ADDRESS: 1133-1145 GRISWOLD

APPLICATION NO: HDC2024-00685

HISTORIC DISTRICT: CAPITOL PARK

SCOPE: INSTALL METAL PANEL CLADDING AND ALUMINUM WINDOWS
(REVISION TO PREVIOUSLY-APPROVED DESIGN)

Alley facing wall, approved in 2023. Area outlined in yellow indicates area of limestone to be retained. Area outlined in light blue indicates area of to be clad with GFRG. Also note windows in east bay

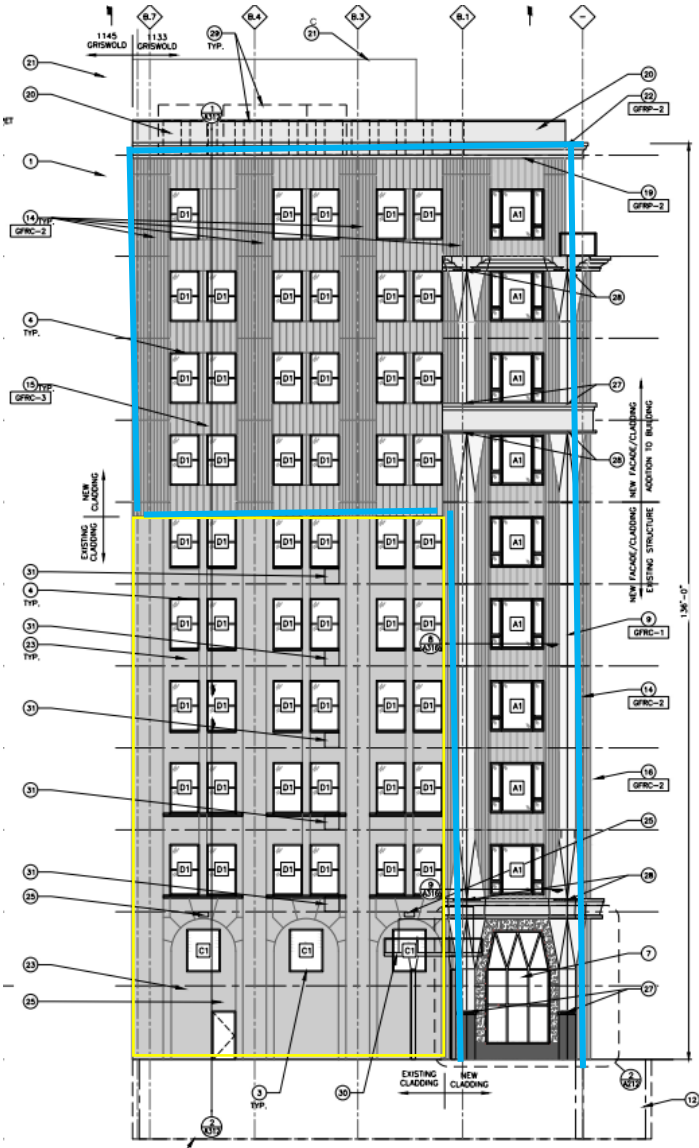
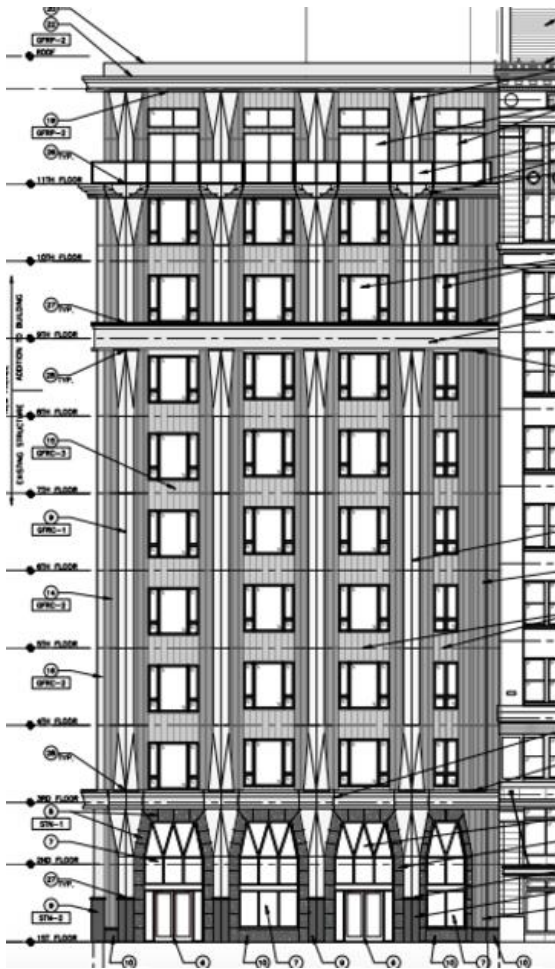
- With the current submission, the applicant is seeking the Commission’s approval to revise the treatment proposed for the building’s exterior cladding. Also, the window type which was approved for installation at the alley facing wall of the original building, at its easternmost portion of the façade is proposed for revision. The applicant has noted the following reasons behind their desired revisions:
 - *“GFRC was originally proposed for the cladding panels but are changed to composite metal panels to greatly reduce the weight of the facade. There is no change to the color or finish of the panels, they will have a matte finish and will be beige- colored as shown on the swatches on sheets A201 and A20.... While concrete block was being removed from the east bay of the alley façade, existing limestone cladding in fair condition was uncovered.*

Alley facing wall, proposed for approve with the current application. Area outlined in orange indicates area of limestone to be retained. Area outlined in blue indicates area of to be clad with metal panel. Area outlined in green indicates area to be clad with composite aluminum siding. Also note windows in east bay will be 1/1 aluminum units.

Front facade, approved in 2023. Wall to be clad with GFRC

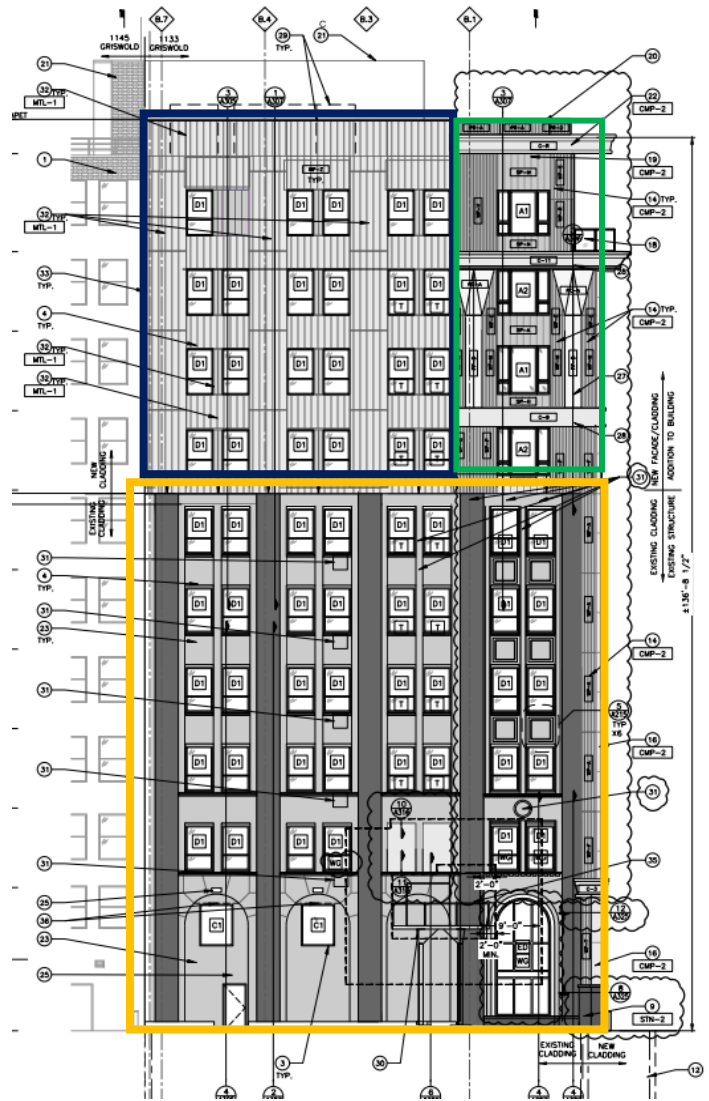
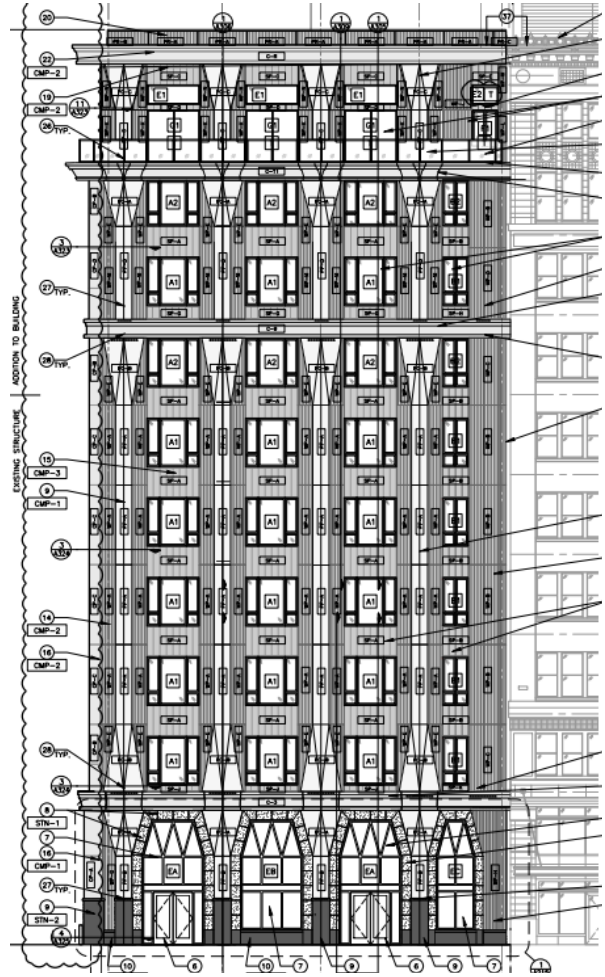
Front facade, proposed for approval with the current application. Wall to be clad with composite metal.
